# MONTE VISTA MEMORIAL GARDENS

## *Response to Comments Document Final Environmental Impact Report*

SCH No. 2020069045

November 2022

SHEET NUMBER: C-4  
ACS JOB NO.: 1112045

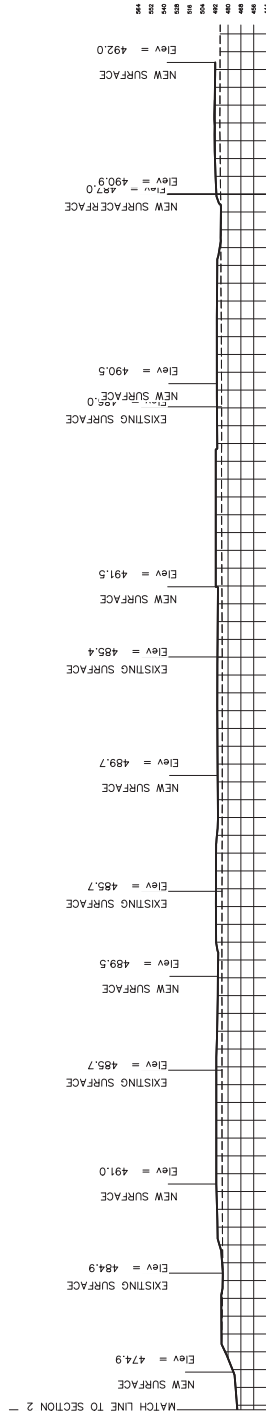
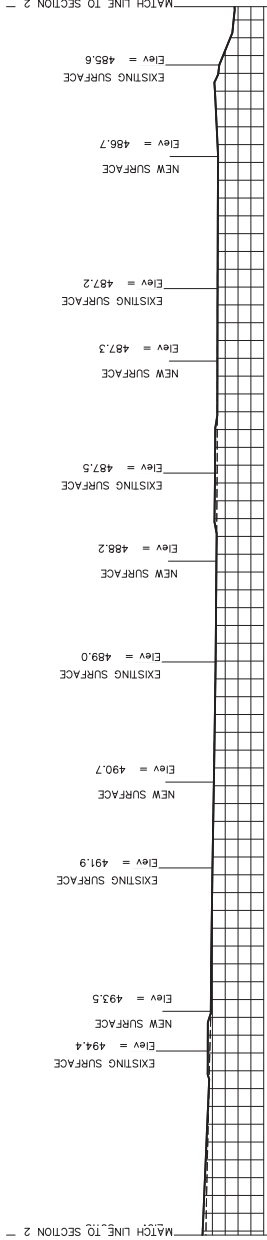
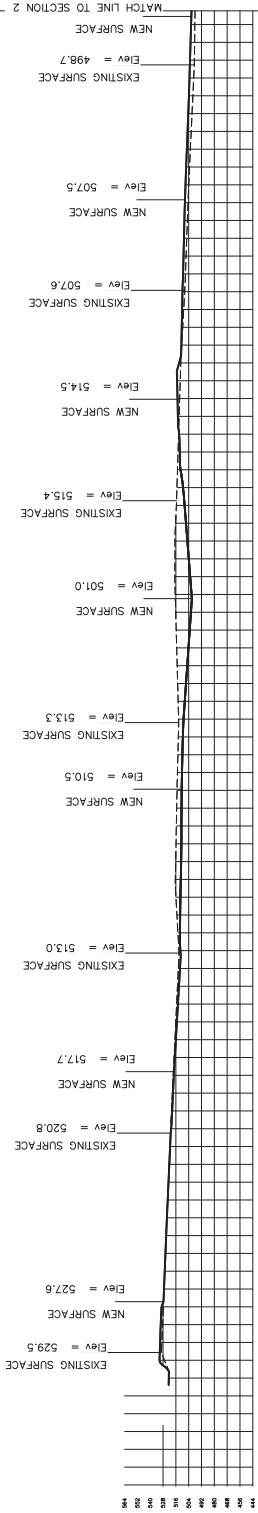
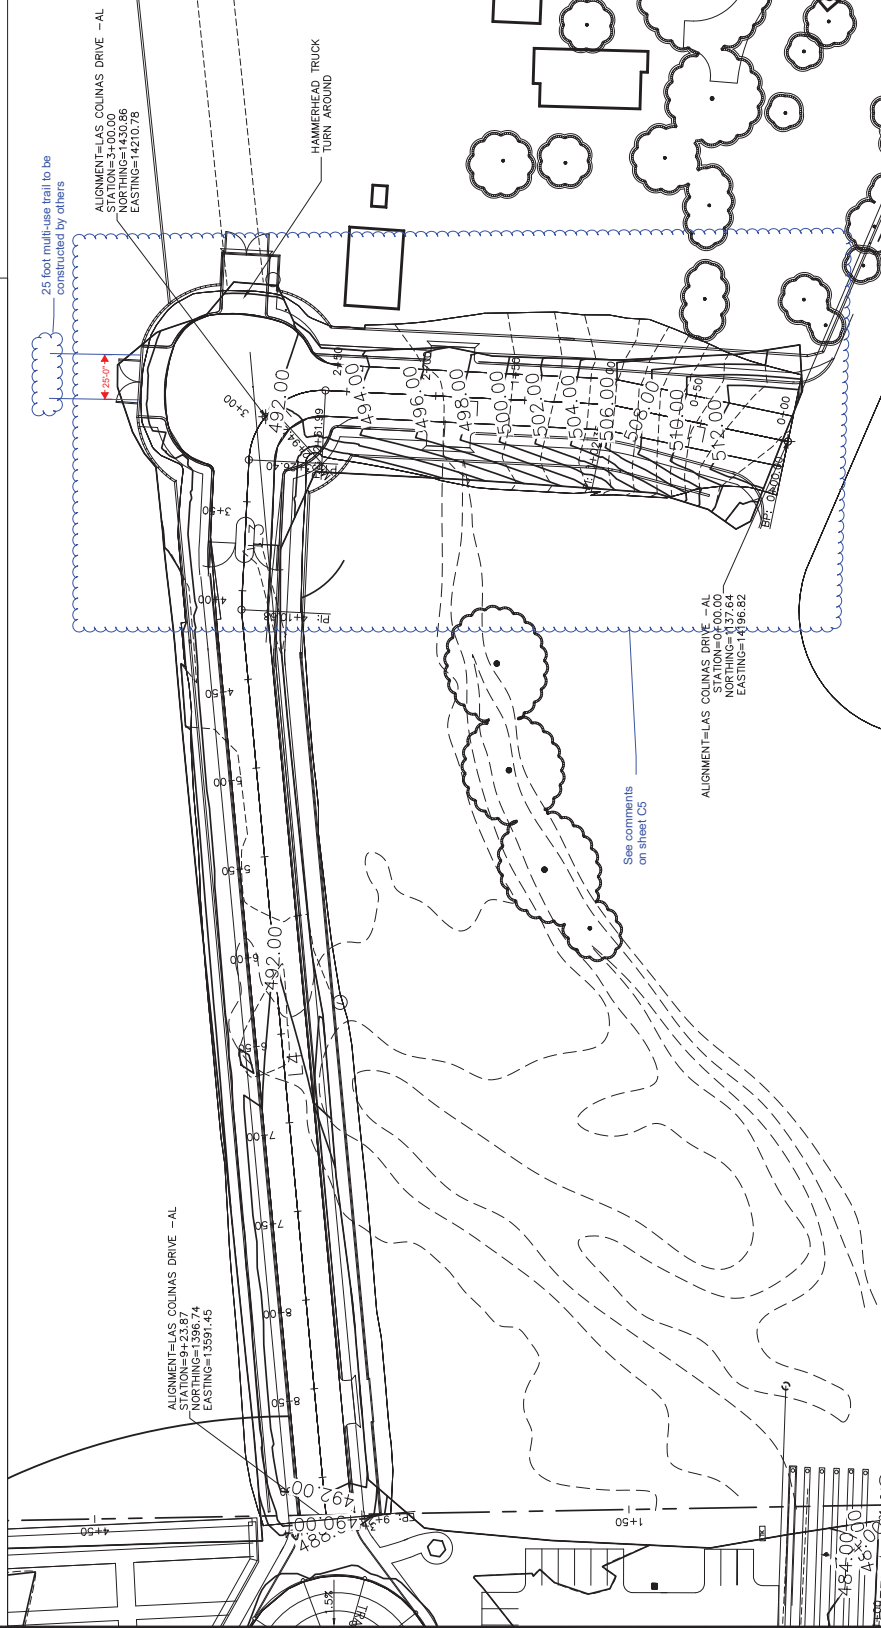
On Sheet C4.1 please address the following concerns:

On Sheet C5 please address the following concerns:

1. Please show the City recommended roadway/trail cross section from station 0+00 to station 3+00 extending north to the existing gate at the north end of the existing cul-de-sac bulb. See the City recommended roadway/trail section marked on sheet C6.
2. Show the proposed vertical curve data on the profile.

Clarify Location of point of connection to County Right of Way

ROAD SECTION 0+50.00

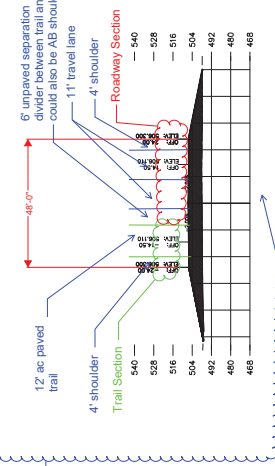
City Preferred street/trail configuration from Station 0+00 to Station 3+25 at end of bulb for connection of future trail to be constructed by others

**Figure 1 – Earthwork Exhibit**  
**Figure 2 – Creek Cross Sections**

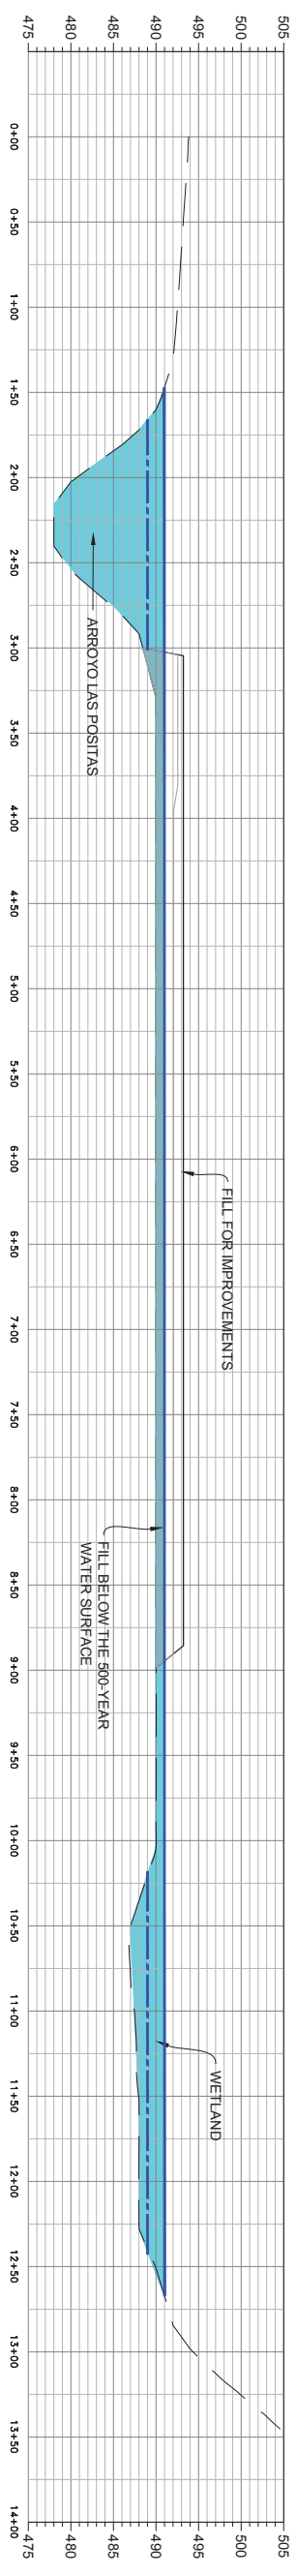
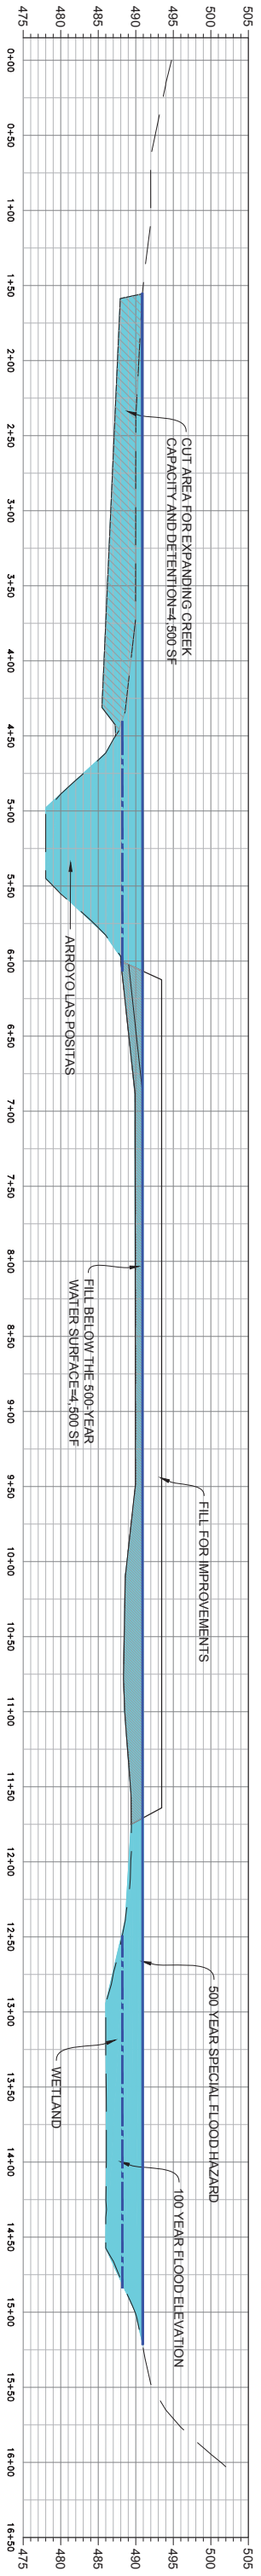
To offset the loss of floodplain in the 500-year special flood hazard area on Phase 1, the project proposes to excavate the floodplain on the opposite side of the creek to increase the channel capacity. Figure 1, Earthwork Exhibit, shows the area that will be excavated to mitigate for the loss of floodplain.

As a result, the creek will have increased capacity, which will decrease peak flows to the pre project levels and lower the water surface to that of the existing condition delineated by FEMA. Figure 2, Creek Cross Sections, provides an illustration of how the proposed grading relates to floodwater elevations.

Section A-A' on Figure 2, is a cross section of the creek and adjacent floodplains upstream of where the excavation is proposed. Section B-B' is a cross section with the expanded flood plain shown. The excavation area will be the same as the area of fill to be placed within the 500-year special flood hazard area, resulting in a cross-sectional area with at least as much capacity as what currently exists.
